Submission on the Galilee Coal Project EIS

(Northern Export Facility), also known as the China First Project

Paola Cassoni & Sonya Duus

19th Dec 2011

Figure 3-5: Geological Map: Barcaldine – Alpha Region (DERM, Per Comms)

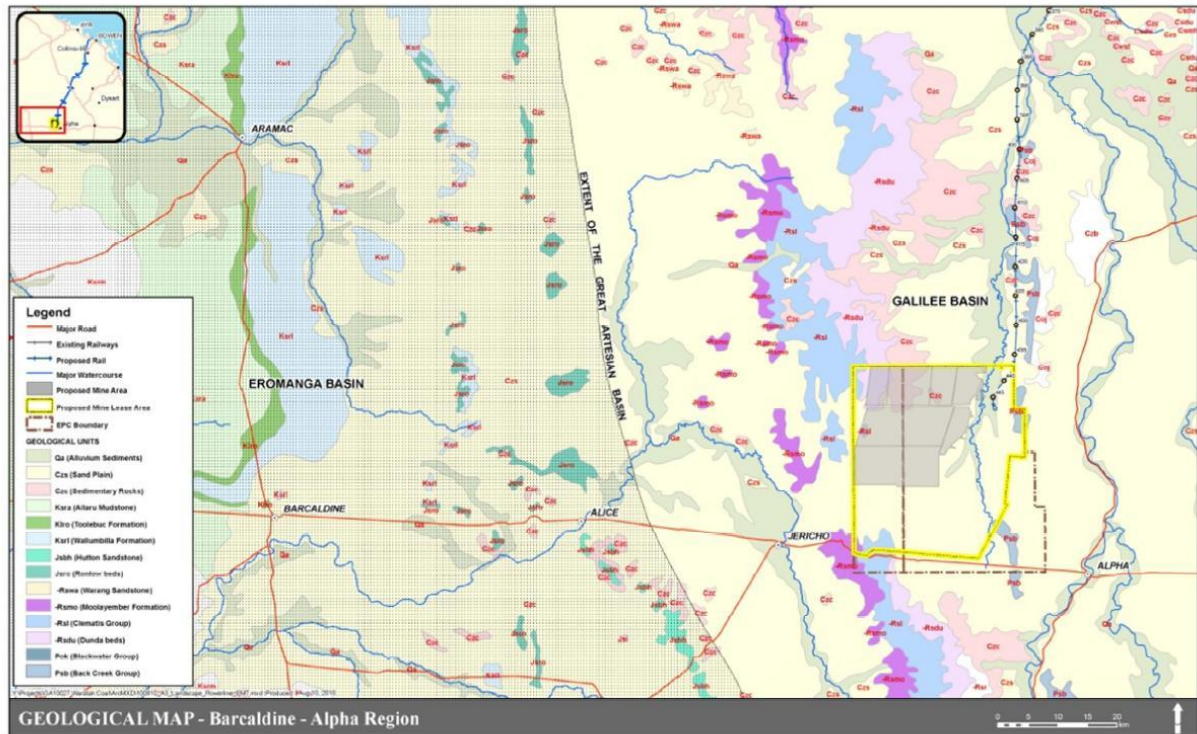
The above map from the EIS indicates that the 'Extent of the Great Artesian Basin' lies around 30-40 km west of the Waratah Coal 'proposed mine lease area'. The source of the above map is named as 'DERM, Per Comms', but no reference is provided in the Reference list on p.10-1. However, it seems that the basis for the above map is the 1972 1:250 000 map available from the Geoscience Australia website,²¹ from which a screen shot of the roughly matching area is provided below. A full image of this map is provided in Appendix E. Note however that there is no such line on the Geoscience map indicating the 'Extent of the Great Artesian Basin'.

The proponent must explain how the incorrect map and description of the boundary of the GAB in relation to the proposed development has affected the analysis of the likely impacts from the proposed development.

COMMENT/SUGGESTION: This Appendix and all related chapters and section of the EIS must be thoroughly revised.

The proponent must provide a clear statement with evidence in regards to the basis of the consultant's groundwater assessment as it relates to the GAB. In particular, it must be explained how the conclusion that 'the mine lies east of the boundary of the GAB' was reached, considering information in its own EIS indicates otherwise.

Portion of 1972 'Jericho' 1:250 000 geology map, sheet SF55-14, from Geoscience Australia

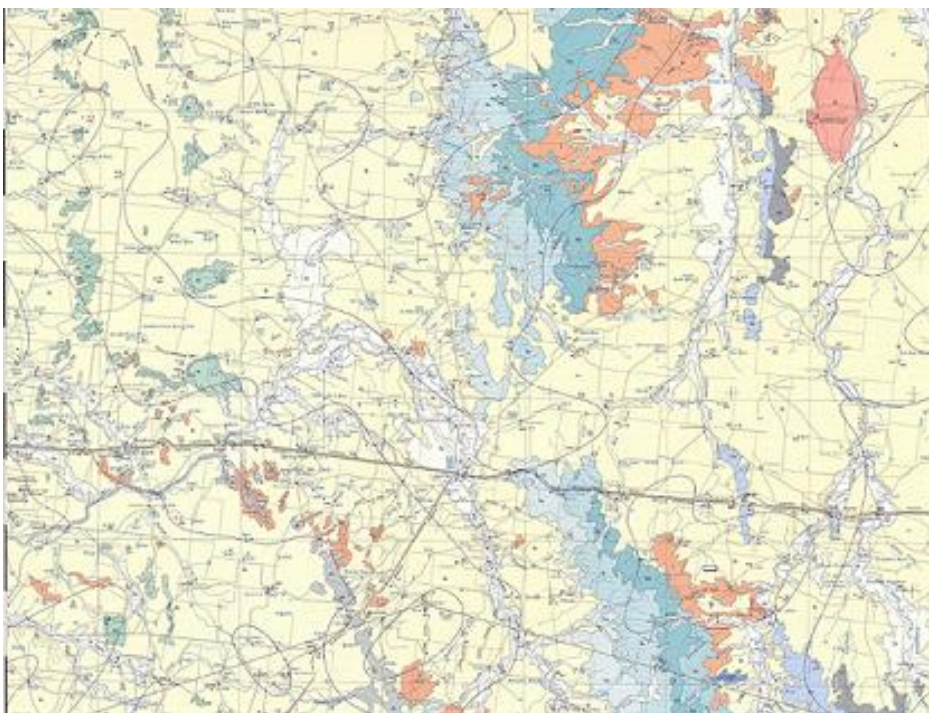
While it is very difficult to read the legend on the map provided in Appendix 14, the original Geoscience map reveals that the formations north and south and slightly overlapping the Waratah Coal tenement area include the 'Lower Triassic Dunda Beds' and the 'Lower to mid Triassic Clematis Sandstone', among others (see original for detail on this).²² The Stratigraphy of the Galilee Basin provided in another section of the EIS helps to explain the relationship between these geological beds:

Figure 7. Galilee Basin Stratigraphy

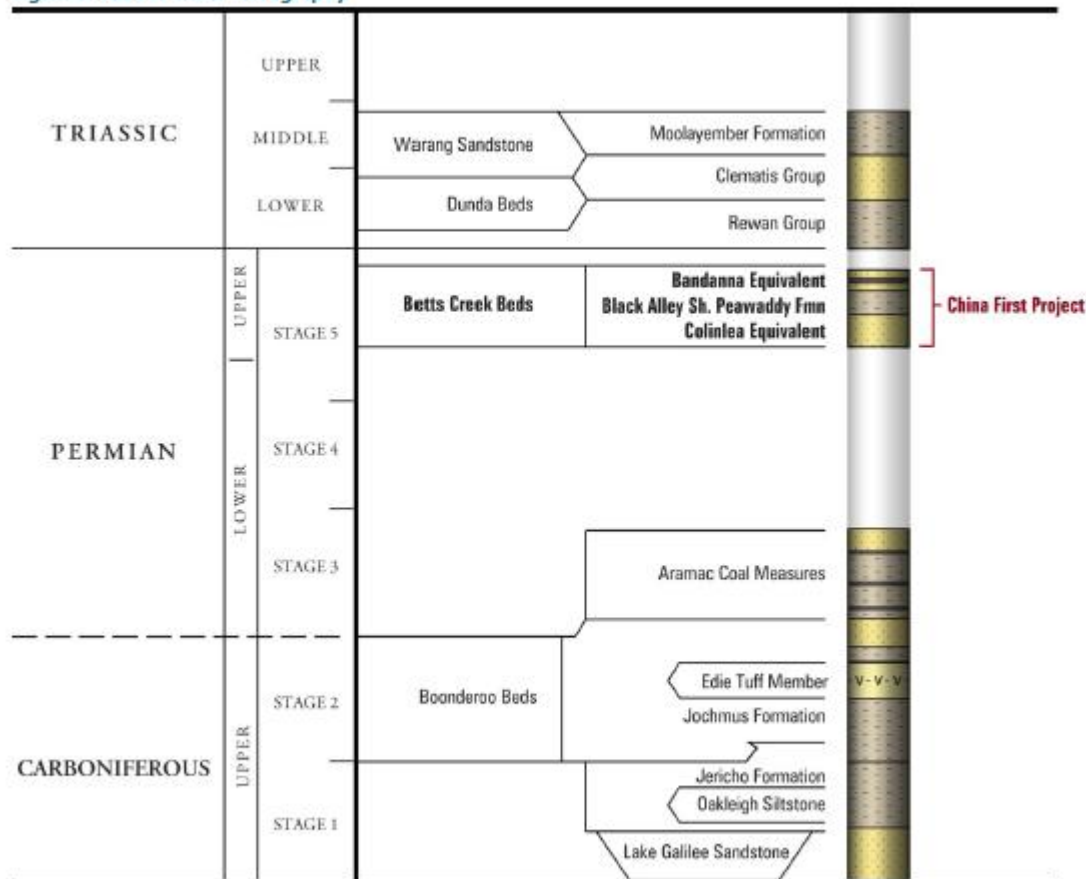
This figure illustrating the Galilee Basin stratigraphy, documents that both the Clematis Sandstone and the Dunda Beds over-lie the coal seams that the proponent wishes to extract.
